1. 조립 오류(6개소) 18점

470808V1012

1. 조립 오류(6개소) 18점

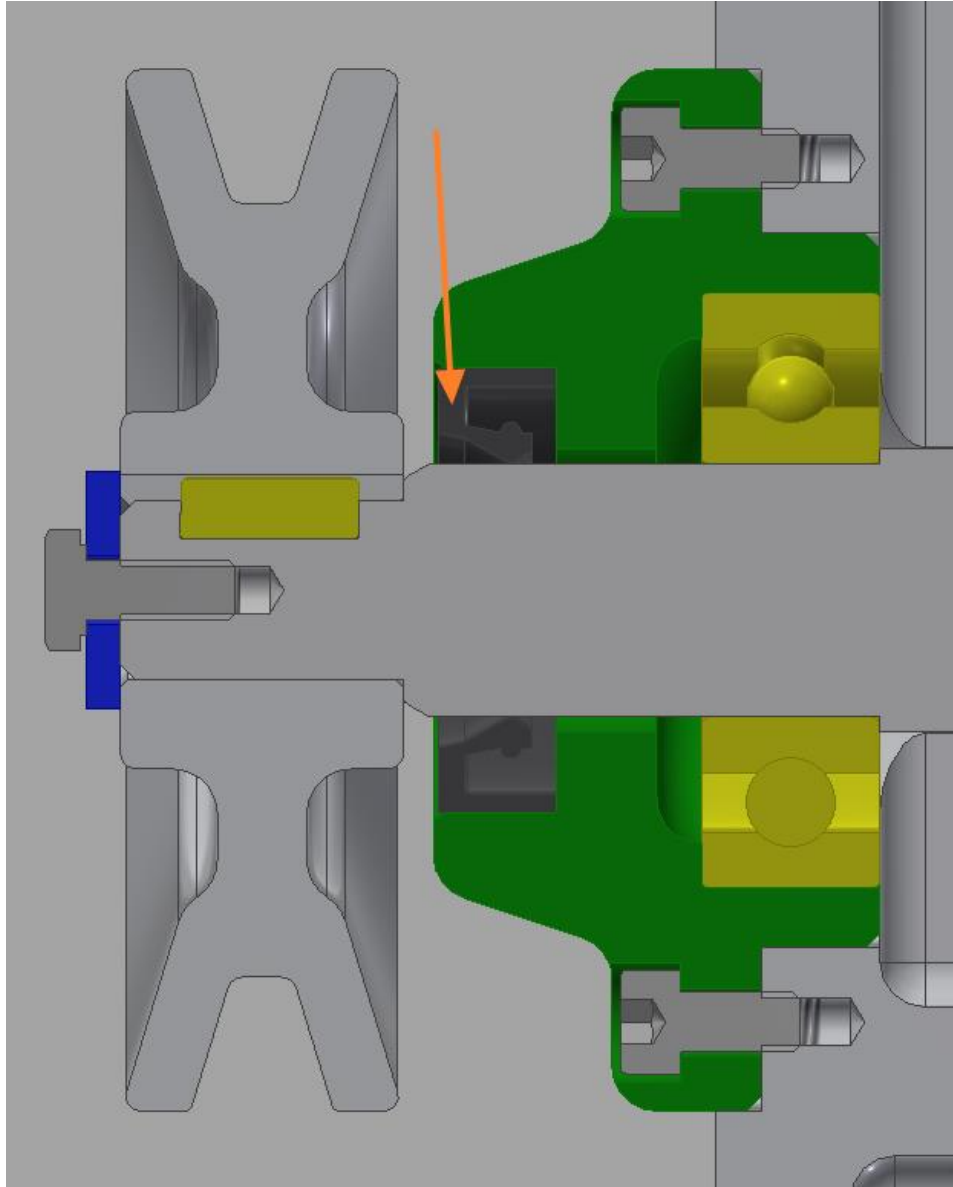
구속 조건 부족 (5개소)

반대 방향으로 조립 (1개소)

"상세뷰 D (2:1)"

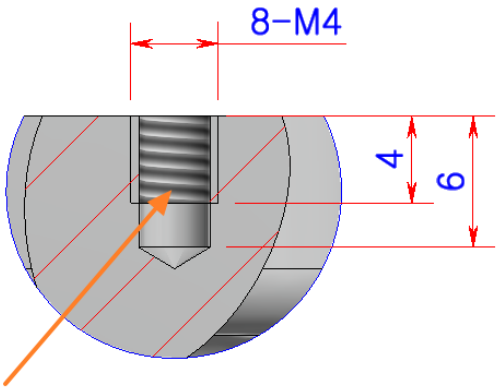
3. 도면 중심선(1개), 치수기입(2개) 6점

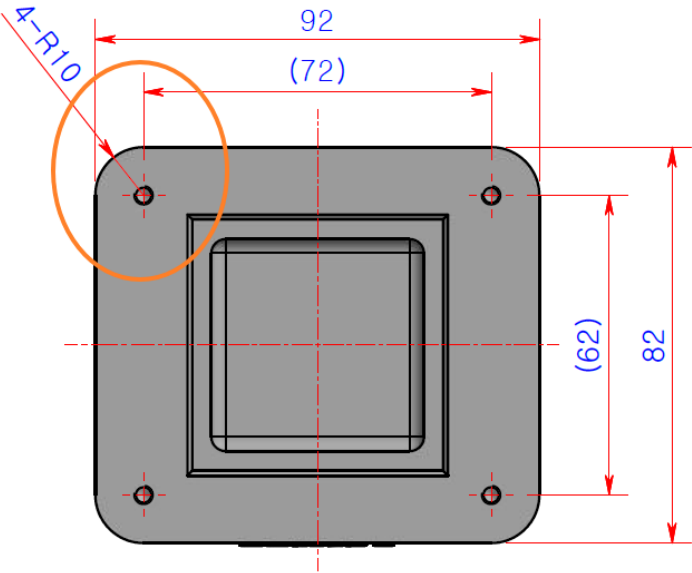
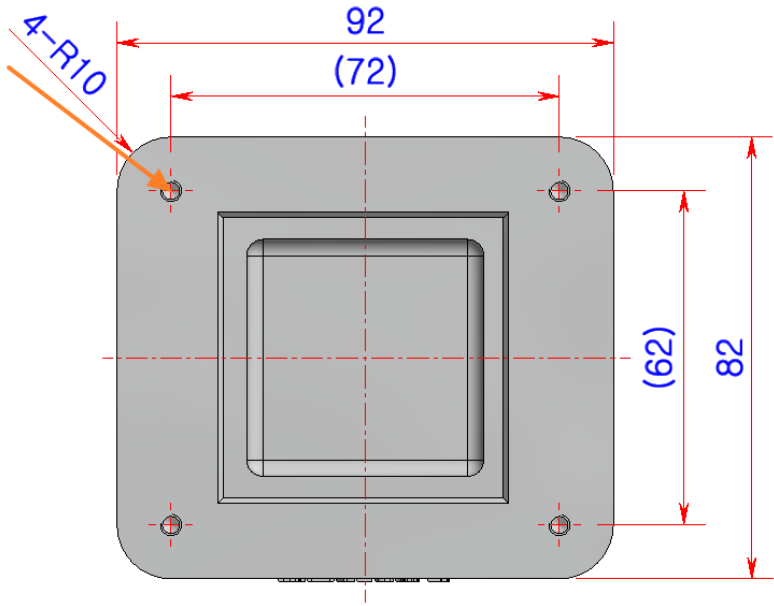
치수기입 표시
